Defense Distribution Depot San Joaquin California  
Tracy Site, Tracy, California

# Explanation of Significant Differences to the Selected Remedies in the ROD for SWMUs 2, 3, 7, and 33, Building 30 Drum Storage Area, and the Northern Depot Soils Area

FINAL

July 2001

**Figure 6-4**  
**Institutional Controls for**  
**SWMU 33- Industrial Waste Pipeline**  
**Defense Distribution Depot San Joaquin - Tracy**

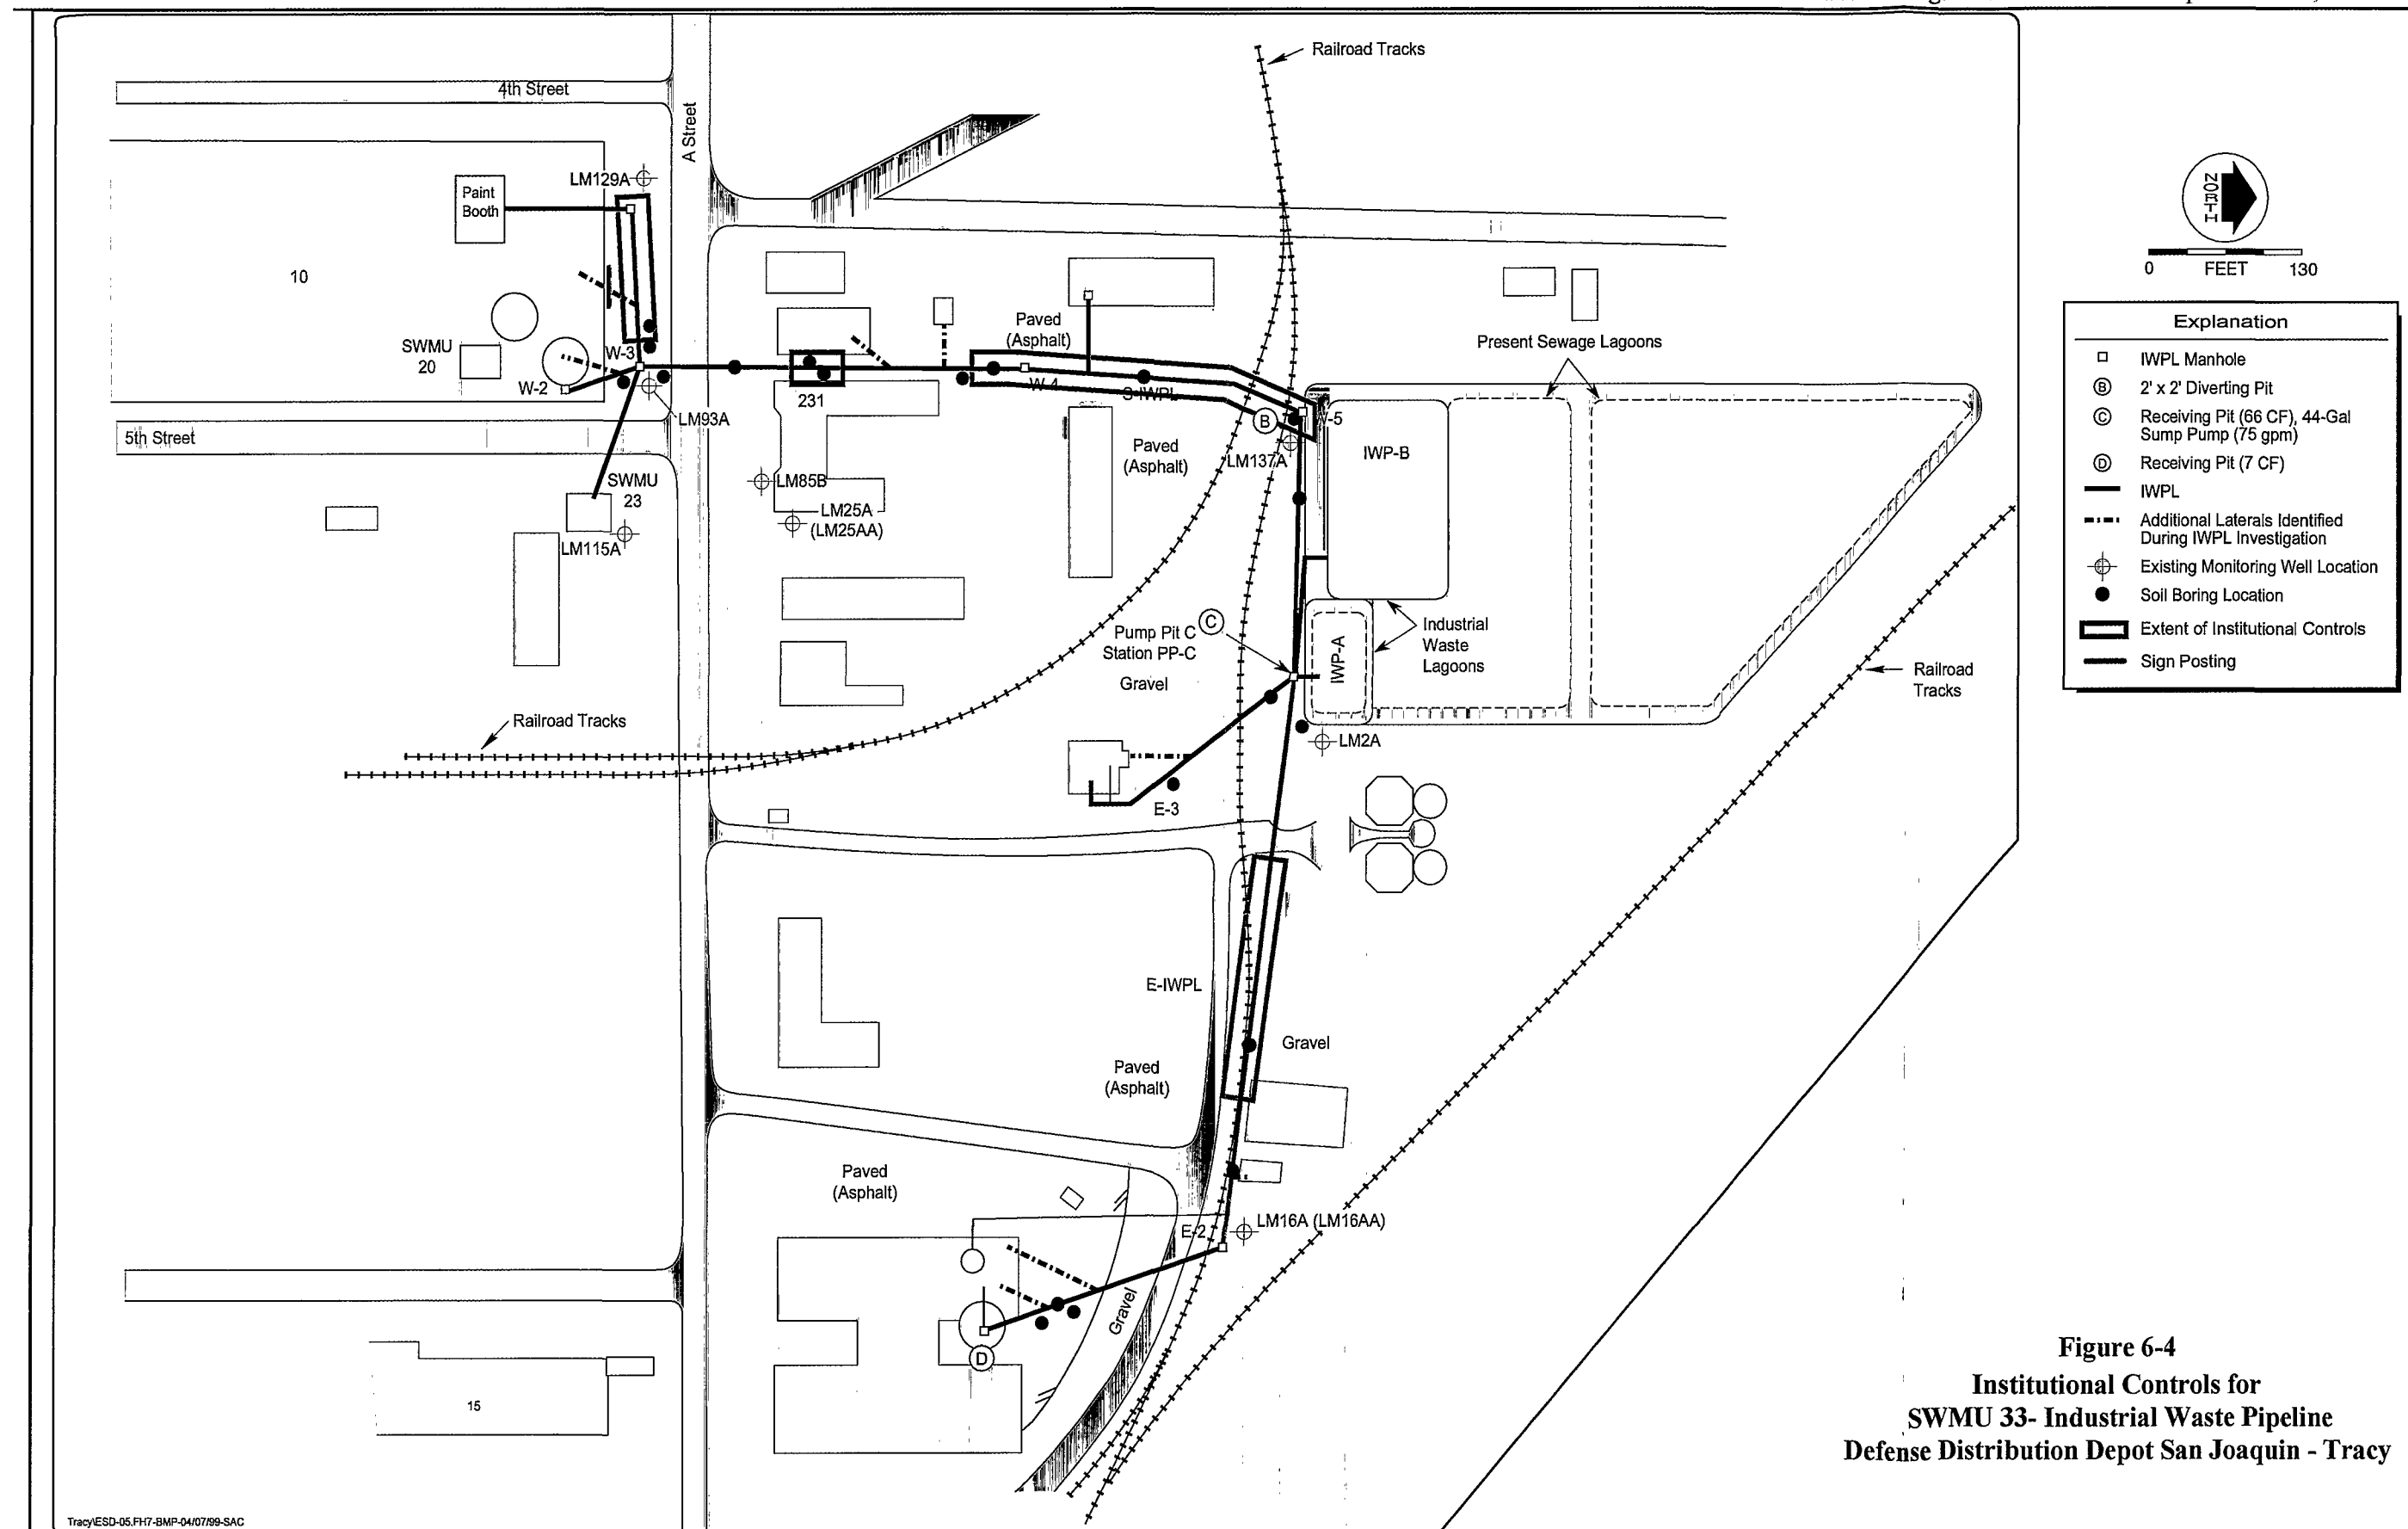
**6.5.5** The selected remedy specifies that for the affected areas of the IWPL shown in Figure 6-4, the signatory parties to the ROD must be notified at least 90 days before any demolition or construction activities that could expose contaminated soil. Figure 6-4 identifies portions of the IWPL that have restricted use. These areas are known to have contaminants present in concentrations that are greater than the cleanup standards identified above. The notification shall include:

**6.5.7** Warning signs will be placed in the affected area, as shown in Figure 6-4. If ownership of the installation is transferred to private or nonfederal entities in the future,
